Year 2 Monitoring Report
DRAFT Bear Swamp Stream & Wetland Mitigation Project

Bear Swamp Stream and Wetland Mitigation Project
Year 2 Monitoring Report
DMS Project ID #100054
Robeson County, North Carolina

**RE: Response to Draft MY2 Monitoring Report Comments dated January 13, 2023
Bear Swamp Stream and Wetland Mitigation Site
Lumber River Basin – CU# 03040203 - Robeson County, North Carolina
NCDMS Project # 100054, Contract # 7516**

BEAR SWAMP STREAM AND WETLAND RESTORATION SITE
 CURRENT CONDITION PLAN VIEW: ASSET MAP
 MY2: 2022
 ROBESON COUNTY, NC

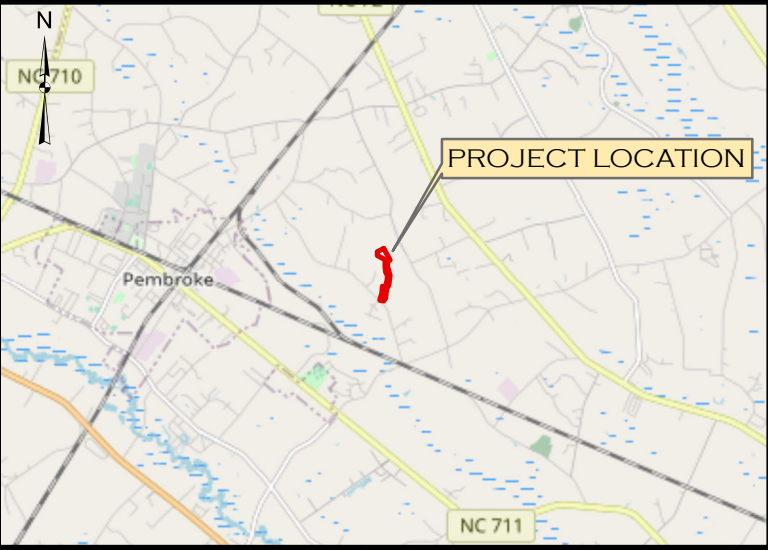
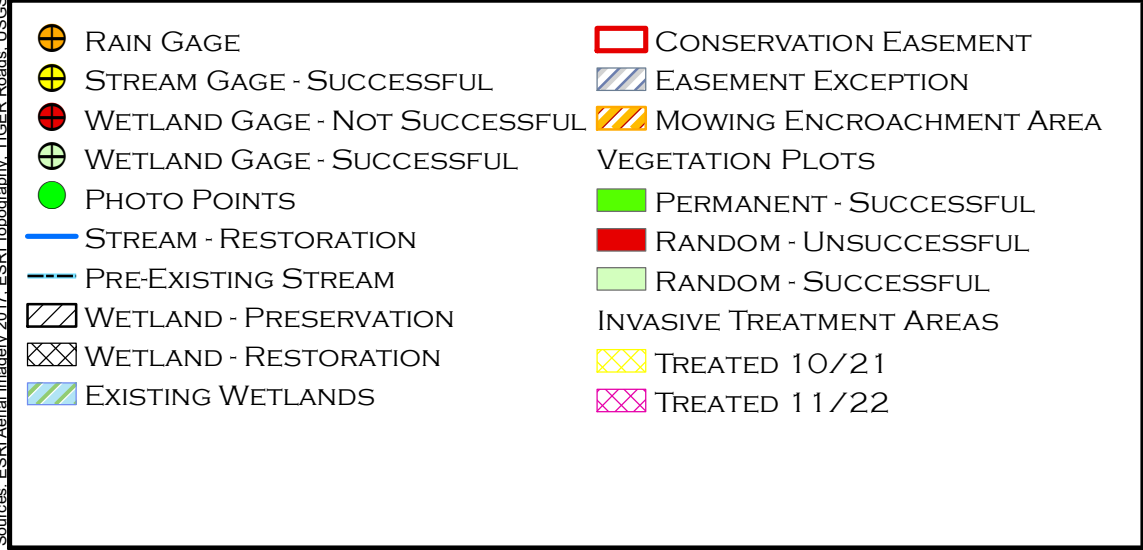
- **Table 6:** *Suggest removing 1-2 stems of overcup oak from Random Plot 3, so it meets the 50% success criteria and removing from the narrative. If you prefer to leave it, suggest changing the color of the plot on the CCPV to green, as it’s meeting the stems/acre requirement.*

- *There are multiple encroachments occurring with varying degrees of severity. Within the report, please detail the adaptive management for the encroachments (timeline, marking, planting, landowner coordination, etc.) and include any additional encroachment areas on the CCPV/Table 5. Photo documentation of completed work must be included in the MY3 report.*
 - Discussion of these encroachments have been added to Table 2 and to the narrative in Section 2.2.1 (Vegetation Monitoring Data). The CCPV and Table 5 have also been updated to reflect conditions at the site.

- **EPR prefers to leave the plot as-is; on the MY1 report comments, it was noted to separately indicate on the CCPV a plot exceeding 50% maximum species concentration, regardless of if it met the stems/acre requirement. To be consistent across monitoring years, the plot color was not changed.**

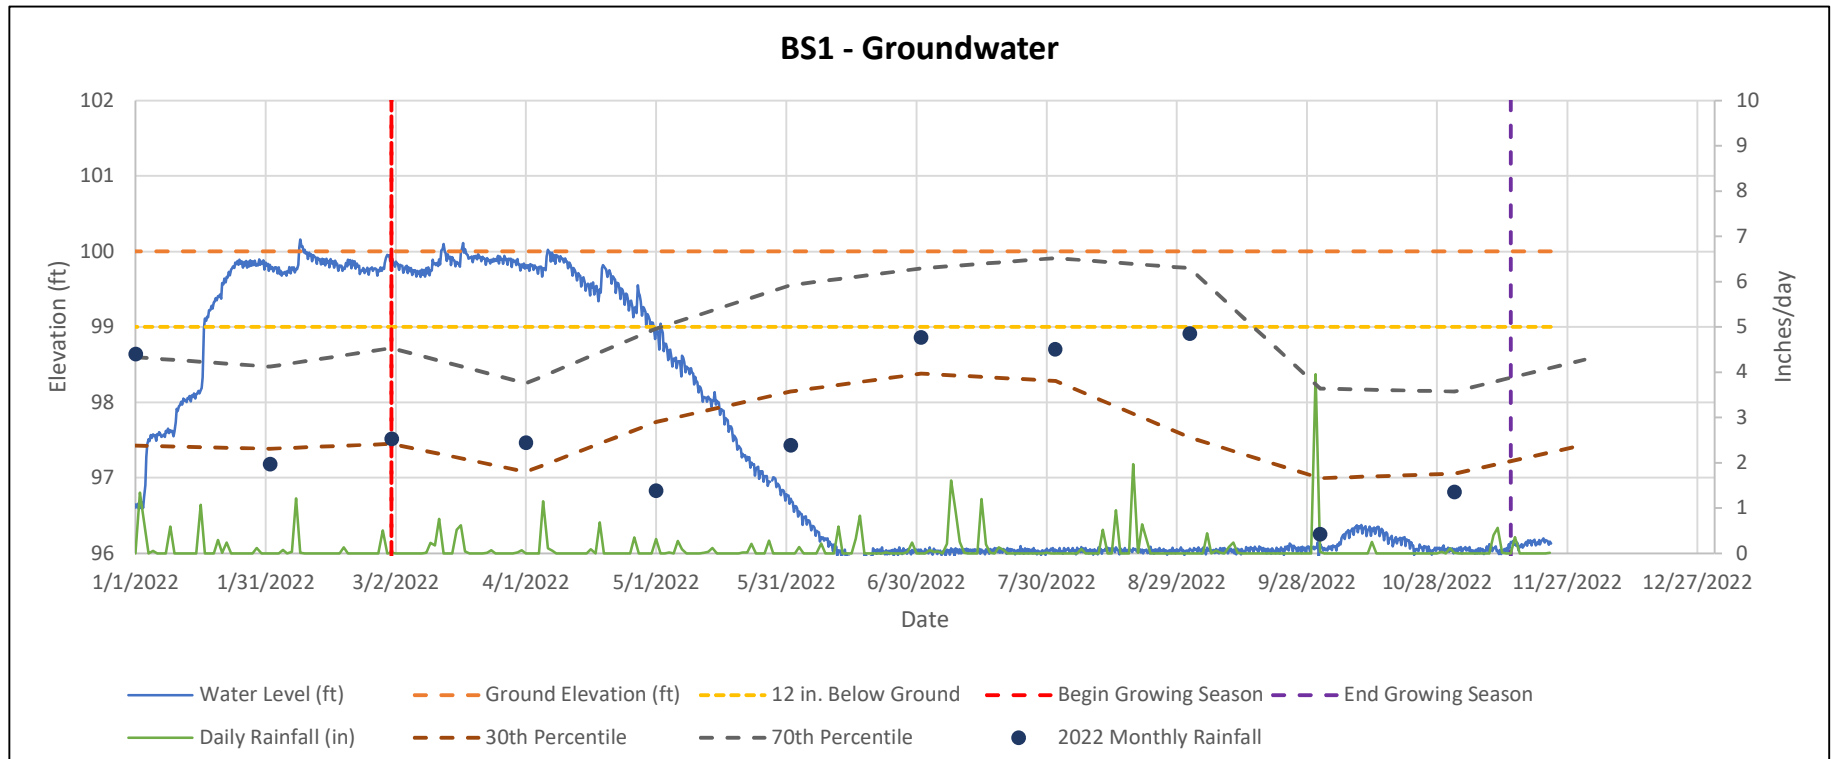
- **Appendix C BS1 Groundwater graph:** *Fix legend for Begin Growing Season.*
 - **Correction made.**
